Addendum #2 - Issued on October 23, 2012

Regarding Bids for **Engineer Road Maintenance Building Shell and Site Work (ITB 12-030P)** for Lucas County Engineer Road Maintenance, bid opening scheduled for October 26, 2012 at 2:00 P.M. (local time).

Lucas County Road Maintenance Building
Bid Package #12-030P – Shell & Site Work Packages
Dated 10/23/2012

ADDENDUM NO. 002

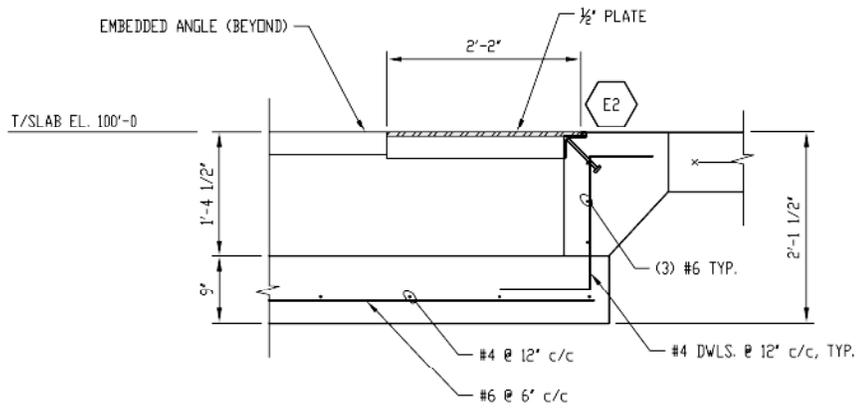
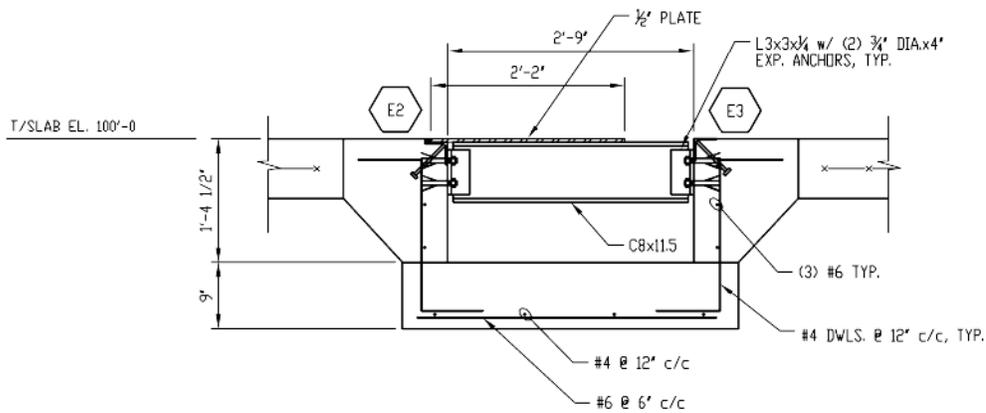
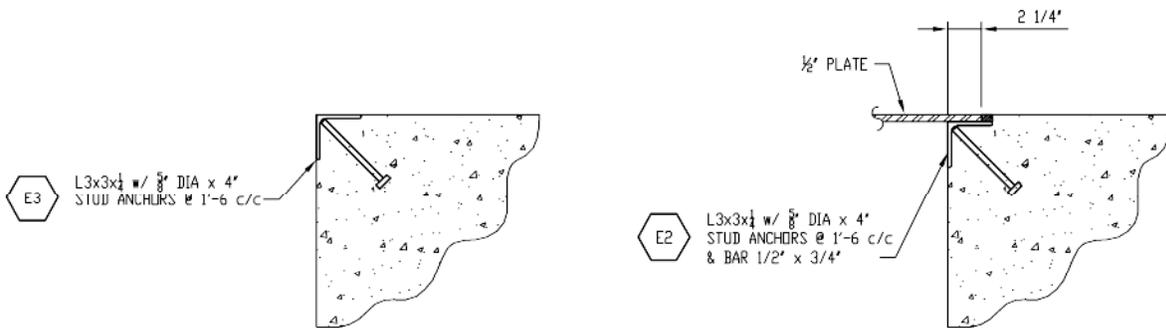
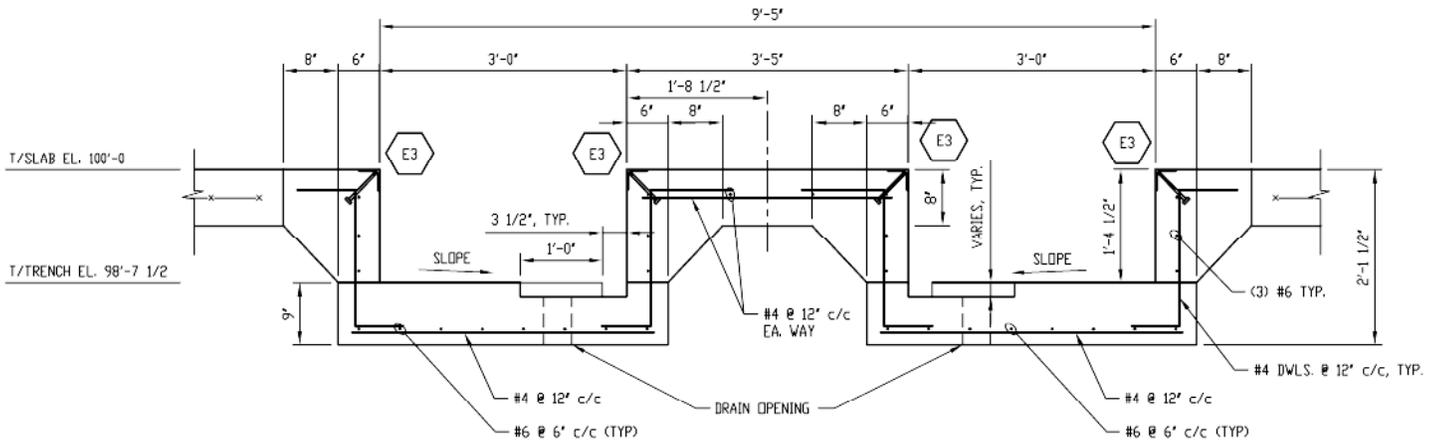
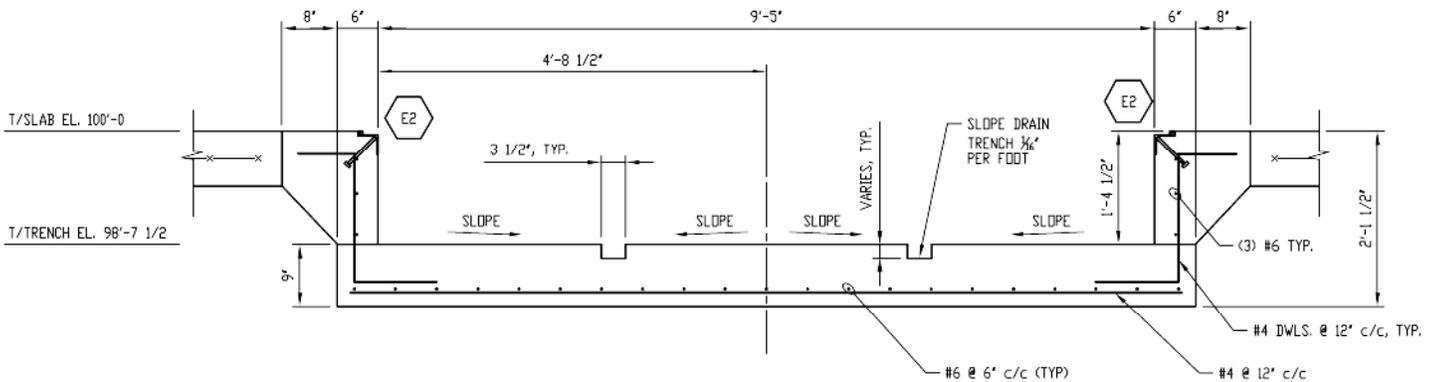
Sketch SKF-03 “LIFT PIT SECTIONS” – New Issue

Item #1 Section details for the recessed vehicle lift equipment pit.

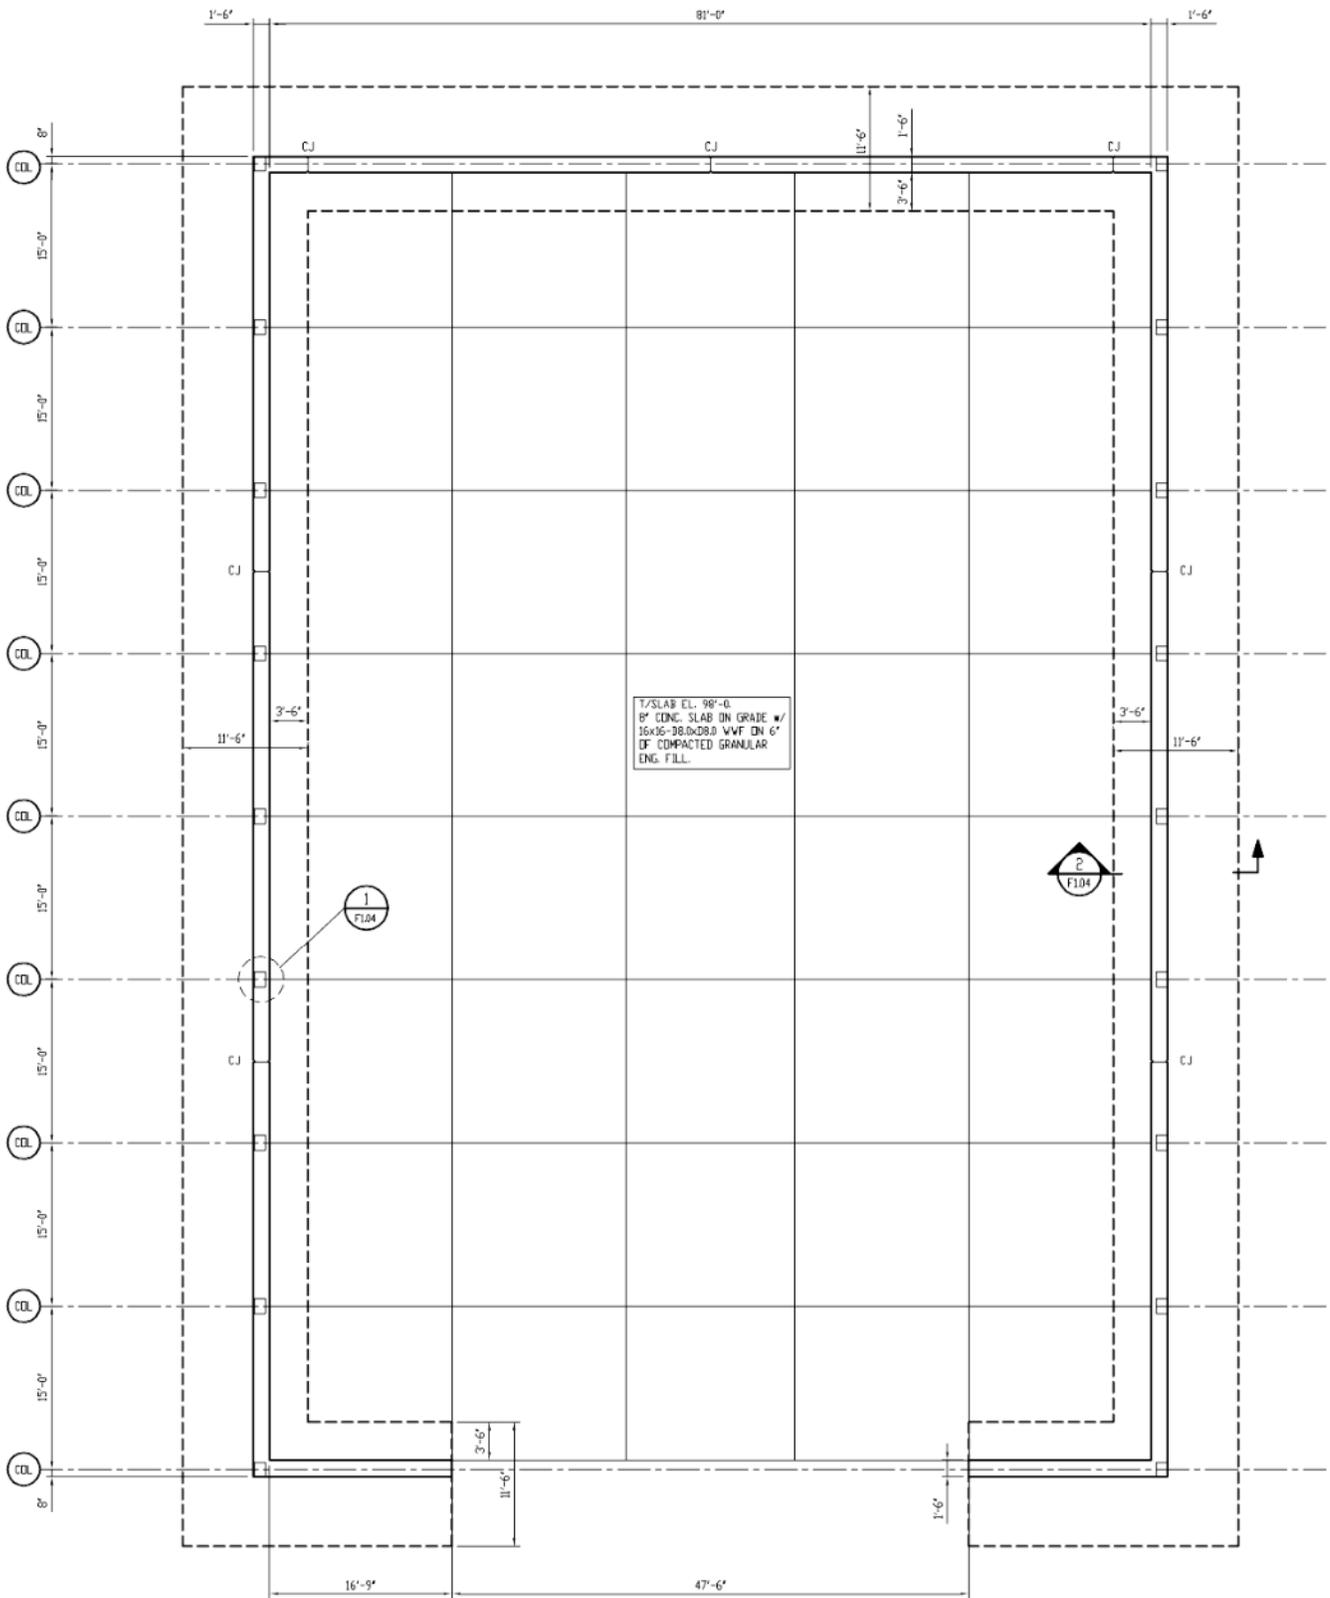
Sketch SKF-05 “SALT BUILDING PLAN” – New Issue

Item #1 Salt Building plan indicating locations of wall control joints.
